UNITED STATES
NUCLEAR REGULATORY COMMISSION
WASHINGTON, D.C. 20555-0001

SUBJECT: TECHNICAL REVIEW OF FINAL INVENTORY AND SPECIAL
ANALYSIS DOCUMENTATION FOR TANK 12H at SAVANNAH
RIVER SITE (DOCKET NO. PROJ0734)

Technical Review of Final Inventory Documentation Supporting Tank 12H Closure

Figure 2 Final Distribution of Solids Used to Determine Residual Waste Volumes for Tank 12H. Legend Provides Thickness of Waste in Inches (1 inch=2.54 cm). Adapted from Attachment A of U-ESR-H-00125.

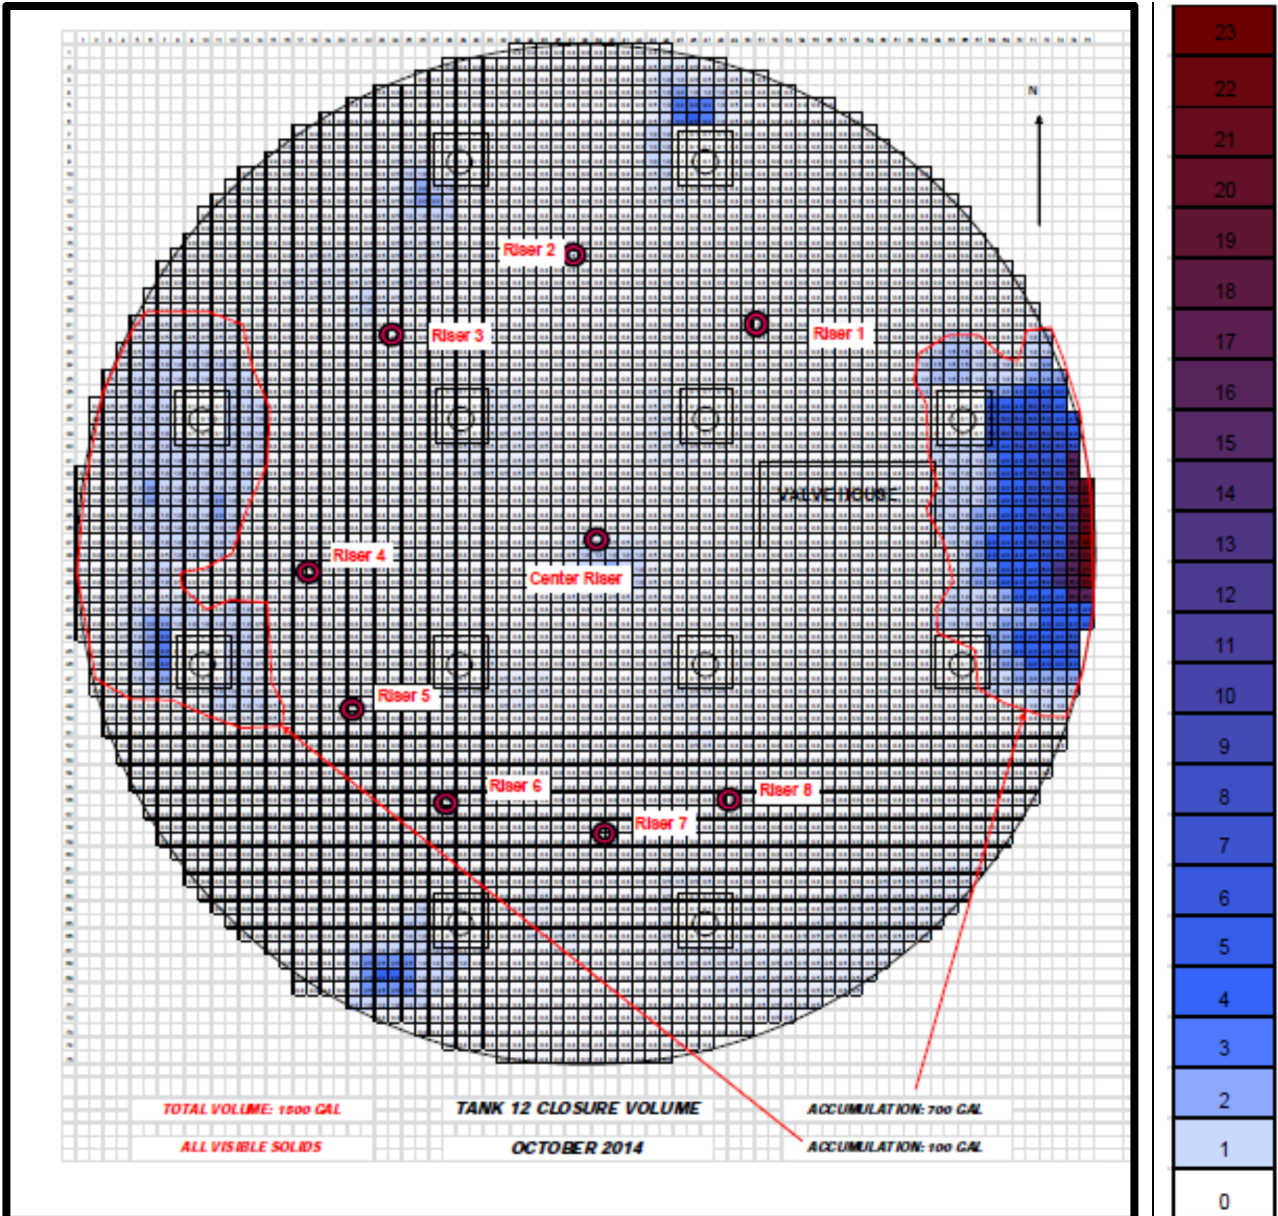
As indicated in previous TRRs, the staff continues to have technical concerns regarding the location and number of samples collected for each of the segments. DOE contractors continue to experience difficulty obtaining samples (e.g., DOE contractors were unable to collect one of six floor samples and did not clearly provide rationale for the number of samples taken from each segment). There may be a benefit from collection of more samples from segments with higher variability or greater volumes, but documentation was unclear on the basis of the sample locations. Initial volume estimates for the mound of residual waste located in close proximity to the valve house was significantly underestimated, as was the case for a similar residual waste mound remaining in previously cleaned tanks (e.g., Tanks 5F, and 6F). Significant errors in preliminary estimates of the relative volumes of segments may negatively impact decisions regarding the number of samples taken from the segments. The staff also noted that material was collected from three boulders on the crawler's path towards the residual waste mound and assumed to be representative of the bottom of the mound. It is unclear whether any samples from the bottom of the mound were attempted or simply assumed to be unnecessary. If the material from the boulders was not representative of the bottom portion of the mound, the composite samples would not well represent the mound concentrations.

Although the best estimate floor volume proportion is around 53 percent (800 gallons [floor] / 700 gallons [mound] + 800 gallons [floor]) (3000 liters [floor] / 2600 liters [mound] + 3000 liters [floor]), the mass fractions of the floor samples used in the composite samples range from 65 to 85 percent (see last column in Table 4) owing primarily to the large differences in densities of the floor and mound samples. However, information on uncertainty in density measurements was not provided, nor was it considered in the volume proportional compositing scheme. Lack of consideration of density uncertainty could be important because of the large variance in density measurements with density of floor samples (range from 0.93 to 1.97 g/ml for the 146 hour air dried bulk density values reported in Table 2 of SRNL-STI-2015-00241, which were used in the compositing protocol [see Tables 4-5 to 4-7 in SRR-CWDA-2014-00103]) being significantly higher than density of mound samples (range from 0.54 to 0.75 g/ml for the 24 hour air dried bulk density values reported in Table 3 of SRNL-STI-2015-00241, which were used in the compositing protocol [see Tables 4-5 to 4-7 in SRR-CWDA-2014-00103]). Composite samples with a disproportionately high mass fraction of floor samples could lead to an underestimate of key radionuclide concentrations because the mound samples may have higher key radionuclide concentrations compared to floor samples particularly for more soluble species (due to limited accessibility and consequently less washing of waste associated with mounds).

Figure 3 High Resolution Photo from Center Riser Taken In August 2013. Image Credit: U-ESR-H-00125.

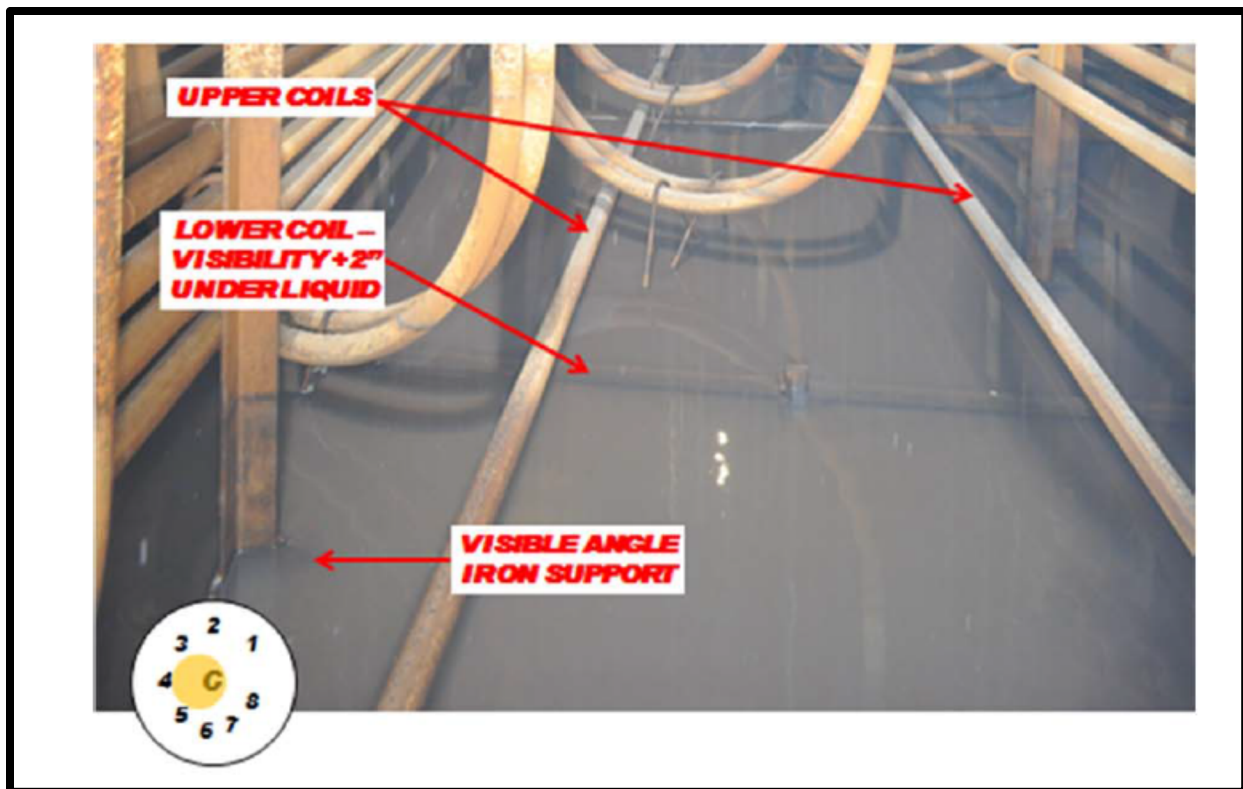
In most areas of Tank 12H, the solids level was below the liquid level when tank solids were mapped (see for example, Figure 3). The presence of liquid waste made it more difficult to map residual solids compared to a situation where significant quantities of liquid waste are not present in the tank. It is unclear why mapping occurred during this time period. Documentation should be more transparent regarding decision-making with respect to when tank solids are mapped, and why mapping occurred while there was still a significant quantity of liquid waste remaining in Tank 12H.
